FACILITY INSTA  Installation  Relocation		ADINESS CHEC  X Start-up Rea  Return from	adiness		Shop Date	ORT #	n/a
FACILITY INFORMATIO	BC-007			LSD:	-	07-05	-063- <b>06W</b> 6M
FACILITY.	Gas Plant	Oil Battery	Compress		tion	x s	atellite X Sweet
Facility Description	Wellhead C		ngle Weil Ba				r Compressor Sour
Business Unit	FH-BC	Superintende		St Mar			preman Dave McAmmond
	X New	In-Service	Acquired	- Pro	evious	 Owner	
Facility Status		m Other Site - Name &		55.1.1	CVICUS		
			_			nhr	Yes X No
General Age of Facil	ity / Equipment			er Acc			
Facility Flow Rate	Design	0 - 280 deks		al Ope			eks - estimated ) kpa - estimated
Facility Max Pressure Facility Max Temp	e Design Design	9930 kpa 93 C		al Ope al Ope	-		- estimated
Facility Min Temp	Design	-29 C	_	al Ope	_		-10 C (during start-up) - estimated
EQUIPMENT INFORMA							
Separator	1 Glycoi (	Contactor		d Heat	er		Air Receiver
Pulsation Dampner	Scrubbe	er <u>1</u> leat Exchanger	Boil	er age Ta	ınk	1	Pop Tank Glycol Flash Drum

## FACILITY INSTALLATION / READINESS CHECKLIST

### INSPECTION SUMMARY:

FACILITY: FH-BC-007 Kakwa	DATE:	November 1	7. 2011 <b>I</b>	REPORT #:	IDR	111117CWa
STATIC DATA						
Prov. Reg. # 602337	CRN: V3	914.2

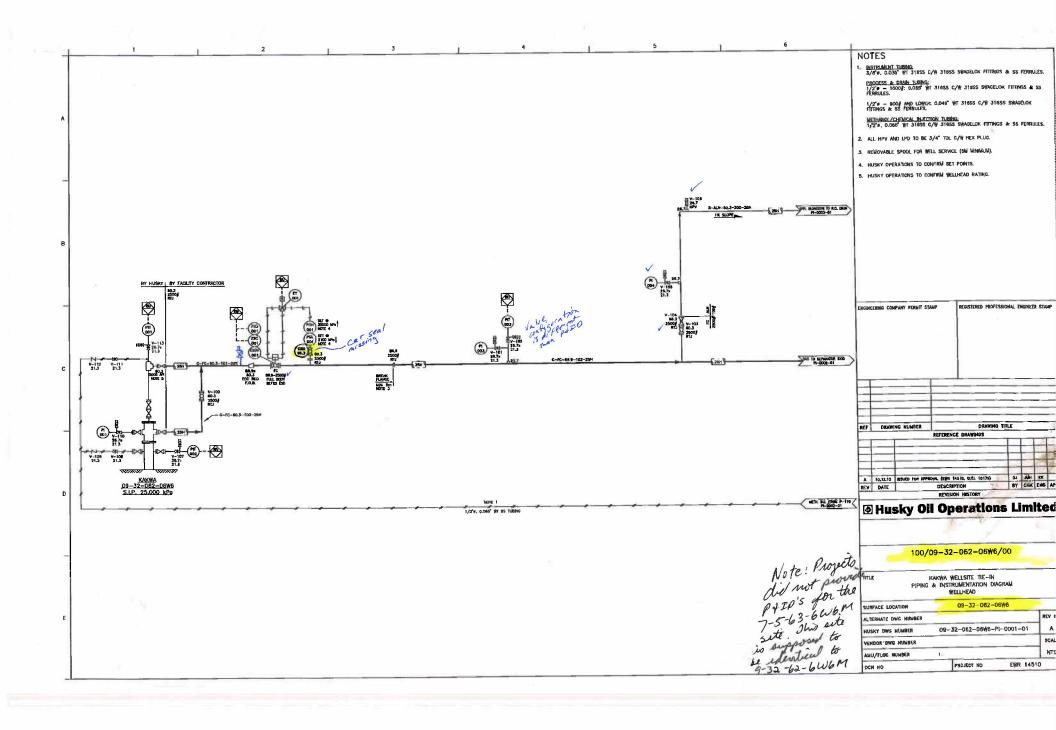
FACILITY: FH-BC-007 Kakwa	DATE: November 18, 201	1 REPORT #: IDR 111117CWb
STATIC DATA		
Prov. Reg. # n/a	CRN: n/a	Serial # D-96-222-10
Equipment Location(LSD): 07-05-063-06	6W6M Equipment ID#	
. , ,	• •	X Sweet
Equipment Description: Water Storage	Tank Service: Proc	duced Water Sour
Manufacturer: n/a		Year Built: 1996
MAWP kPag / psi @	OC/F MDMT:	OC / F Capacity: m3
IDENTIFIED DEFICENCIES		
Level 3 IDR: Faulty welding, piping		
joint make-up or flange connection		1 A CONTRACTOR OF THE CONTRACT
(no immediate safety hazard repair or		
replace at next outage)	1 1	Compromised Flex Hose
Flex hose is not installed correctly.		IDR#111117CWb
According to DS-PF-05 Metallic Flex		
Hose specification		
1000

8.1 Care must be taken to ensure that		
the flex hose is not subjected to		
excessive stresses or other		
mechanical forces during the installation process.		TE TO THE PARTY OF
mstallation process.		
RECOMMENDED ACTION		
LEAVE "AS-IS" X PERFOR	M REPAIR PERFORM	ALTERATION REPLACE UNIT
INTEGRITY ASSESSMENT REQUIR	ED	7.
Comments:		
Replace gasket		
INSPECTION PERFORMED BY		
	54B W0D5070B	NITE A STEEL WAS EAST
QUALITY INSPECTOR X LI	EAD INSPECTOR CO	NTRACTED INSPECTOR
Print Name	Signature	November 18, 2011
	Signature	Date
DEFICIENCY REPORT ISSUED TO		
Name Dave McAmmond Area Fo	Position	Date
	ance Planner	November 18, 2011 November 18, 2011
	stream Lead Inspector	November 18, 2011
Deniv Dollman VVC. Dis		
Jane Yan Data Int	tegrity Administrator	November 18, 2011
Jane Yan Data Int  RECOMMENDED ACTION COMPLETED	egrity Administrator	
Jane Yan Data Int	egrity Administrator	
Jane Yan Data Int  RECOMMENDED ACTION COMPLETED	egrity Administrator
